UNITED STATES PATENT AND TRADEMARK OFFICE

APPLICATION NO.	FILING DATE	FIRST NAMED INVENTOR	ATTORNEY DOCKET NO.	CONFIRMATION NO.
10/749,685	12/31/2003	Steven T. Adamy	55216	2168

Office Action Summary

DETAILED ACTION

Figure 3

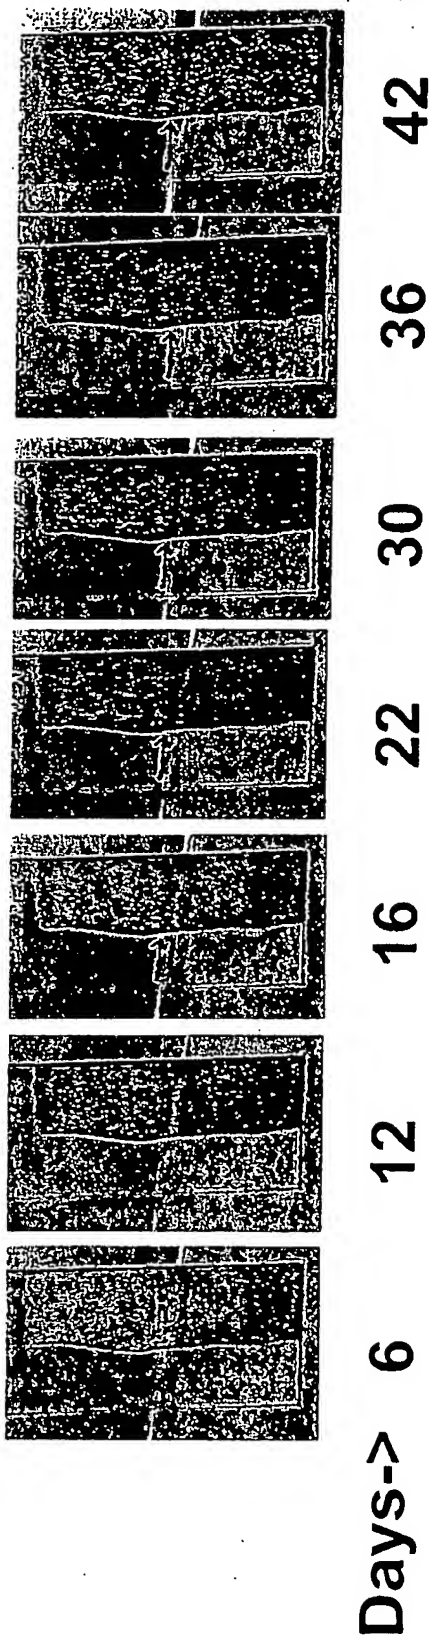
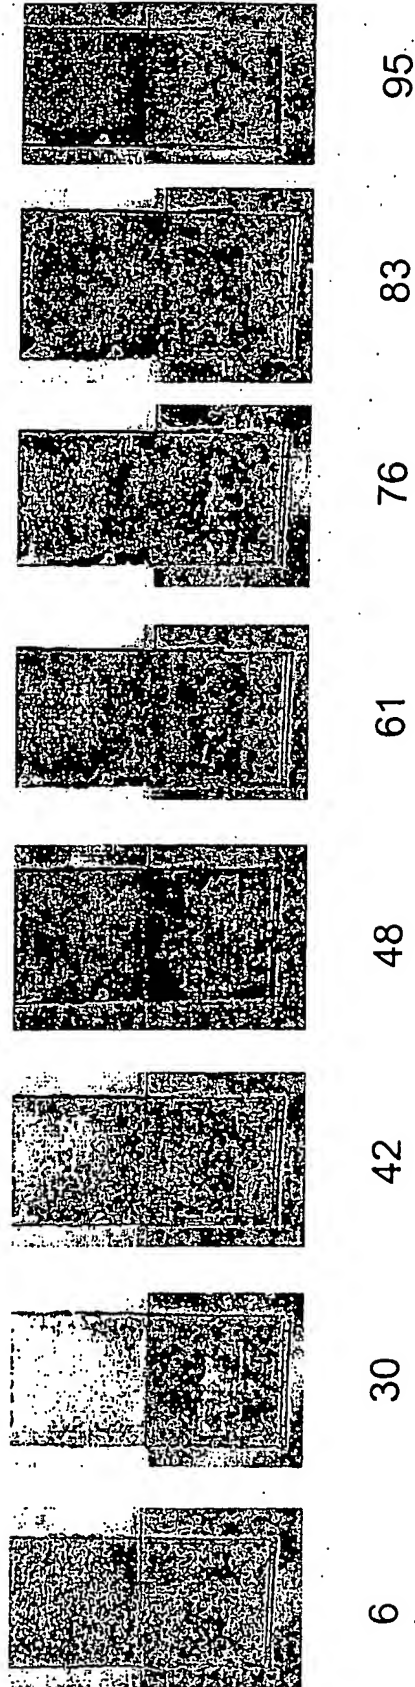
1. The drawings are objected to under 37 CFR 1.83(a). The drawings must show every feature of the invention specified in the claims. Therefore, diagrams showing the structure disclosed in the limitations of claims 1-8 must be shown or the feature(s) canceled from the claim(s). No new matter should be entered.

Not Approved
TmR 2/6/04
